From: Kevin Maguire <kmaguire831@gmail.com>
Sent: Friday, February 21, 2025 4:17 PM
To: City Council
Subject: 2.27.2025 City Council Meeting Agenda Item 7b Based on the Bay Avenue Corridor Study, the roundabout option (Alternative 2) presents several negative impacts on side streets and other streets with stop signs: 1. Increased Traffic on Side Streets Traffi...

Figure 12: Year 2024 Existing Corridor Average Travel Times

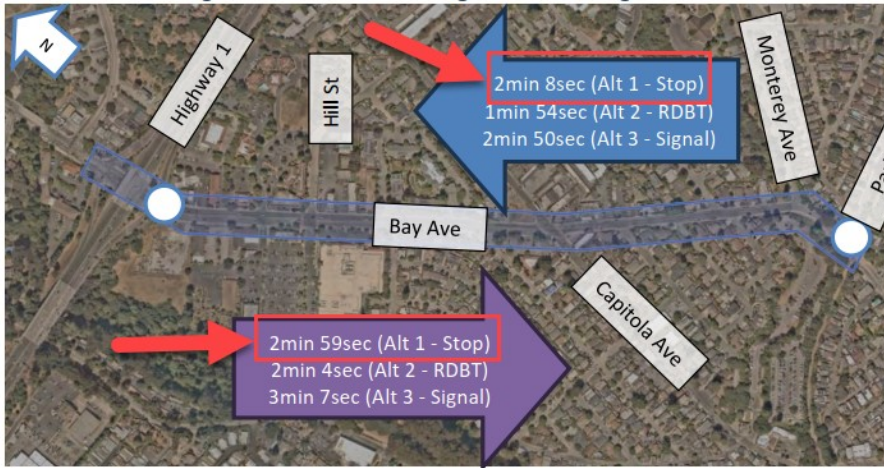
I found some flawed data, there might be more

Vehicles traveling northbound on the Alternative 1 Stop layout would have an average peak hour travel time of 2 minutes 9 seconds, and the estimated annual VHT from Park Avenue to SR1 is 62,501 vehicle-hours. The Alternative 2 Roundabout layout would have an average peak hour travel time of 1 minute 54 seconds and would have an annual VHT of 55,492 vehicle-hours. The Alternative 3 Signal layout would have an average peak hour travel time of 2 minutes 50 seconds and would have an annual VHT of 82,726 vehicle-hours.

Similarly, vehicles traveling southbound on the Alternative 1 Stop layout would have an average peak hour travel time of 3 minutes 59 seconds, and the estimated annual VHT from SR1 to Park Avenue is 98,494 vehicle-hours. The Alternative 2 Roundabout layout would have an average peak hour travel time of 2 minutes 4 seconds and would have an annual VHT of 68,188 vehicle-hours. The Alternative 3 Signal layout would have an average peak hour travel time of 3 minutes 7 seconds and would have an annual VHT of 82,726 vehicle-hours.
